AIRWORTHINESS DIRECTIVE

Grob Twin Astir (Not G103)
All Serial Nos.

GFA AD 256	Issue 1
3/8/1983	Sheet 2 of 2

IMPROVED ATTACHMENT OF FRONT COCKPIT
SEAT SUPPORTS TO FUSELAGE SKIN.

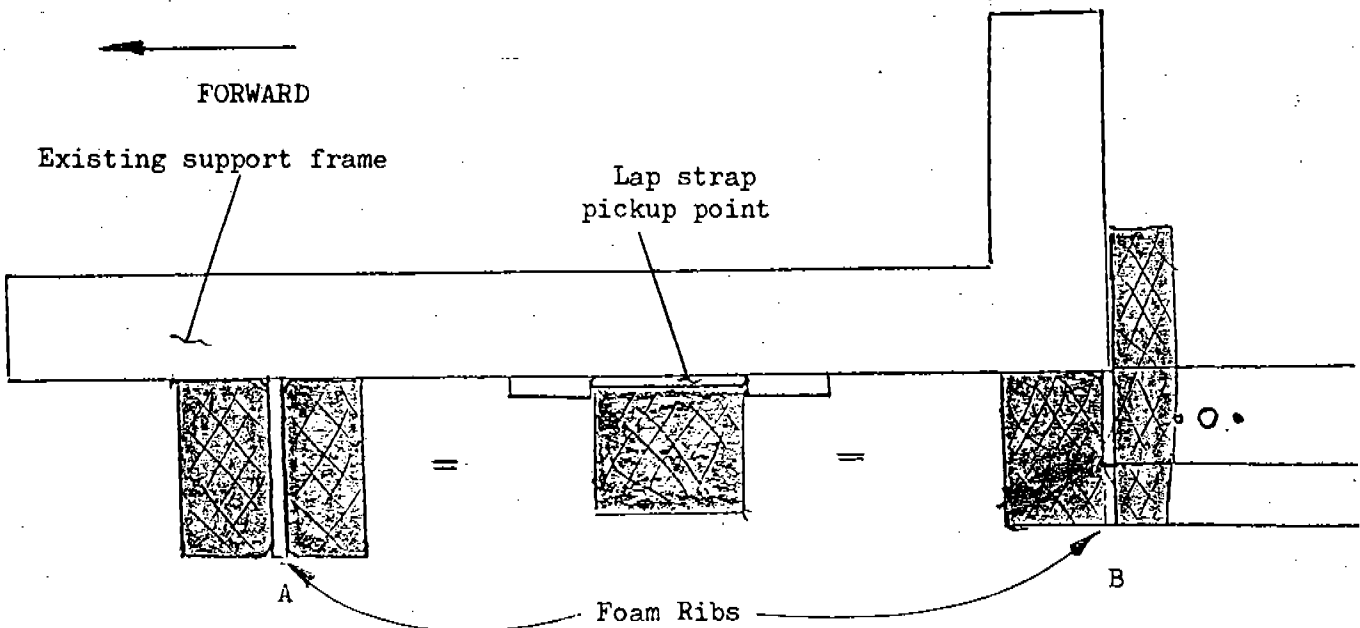
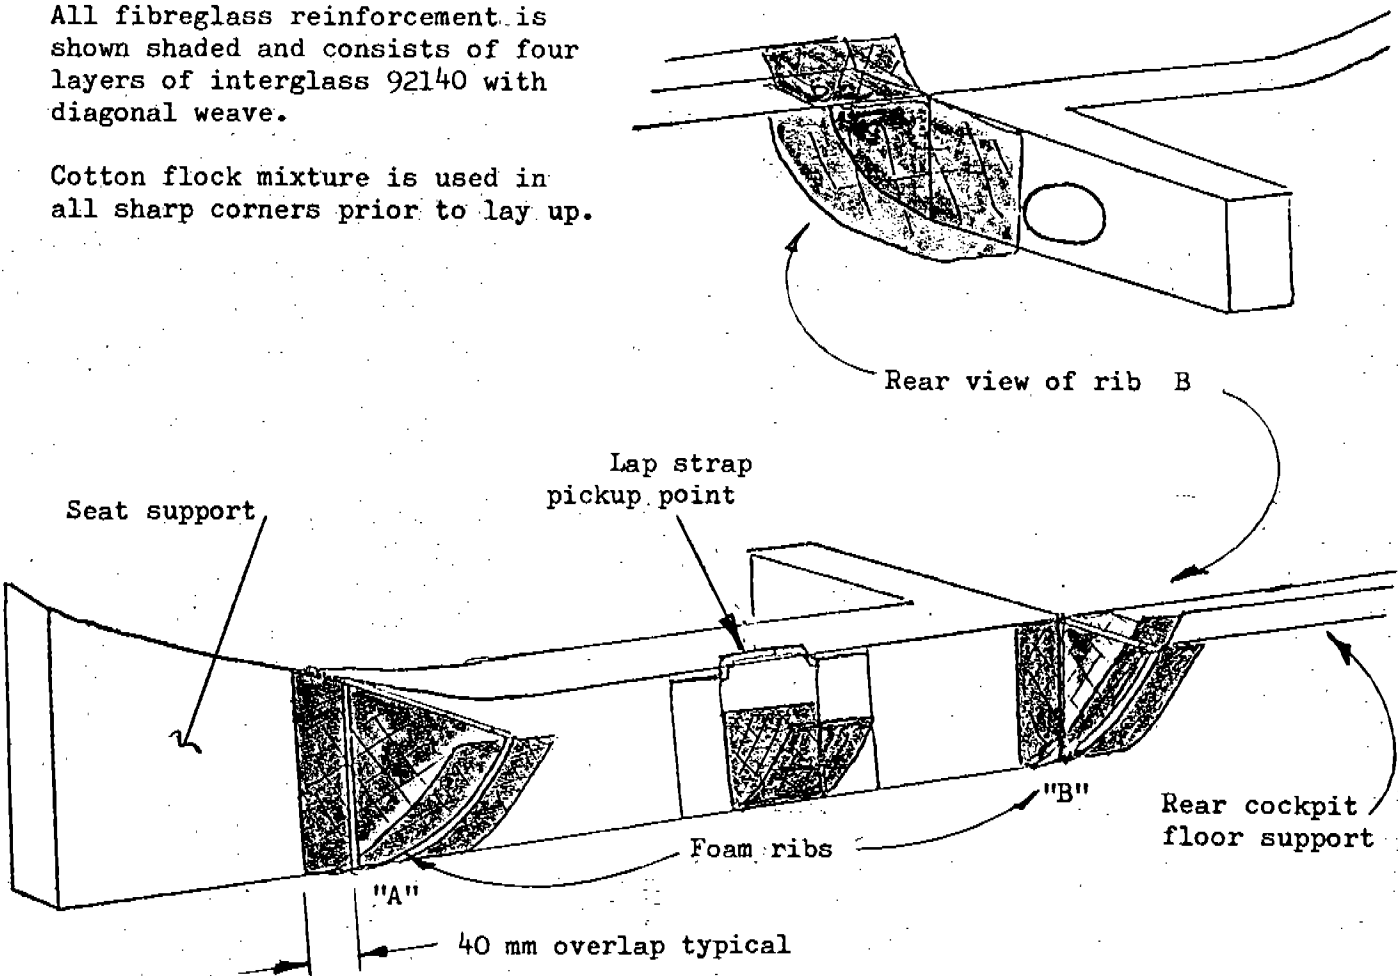
Sheet 2 outlines reinforcement of the attachment of the two underseat frames and the fuselage shell to improve load carrying ability under dynamic conditions.

Foam ribs "A" and "B" are cut from 8mm thick Conticell foam.

All fibreglass reinforcement is shown shaded and consists of four layers of interglass 92140 with diagonal weave.

Cotton flock mixture is used in all sharp corners prior to lay up.
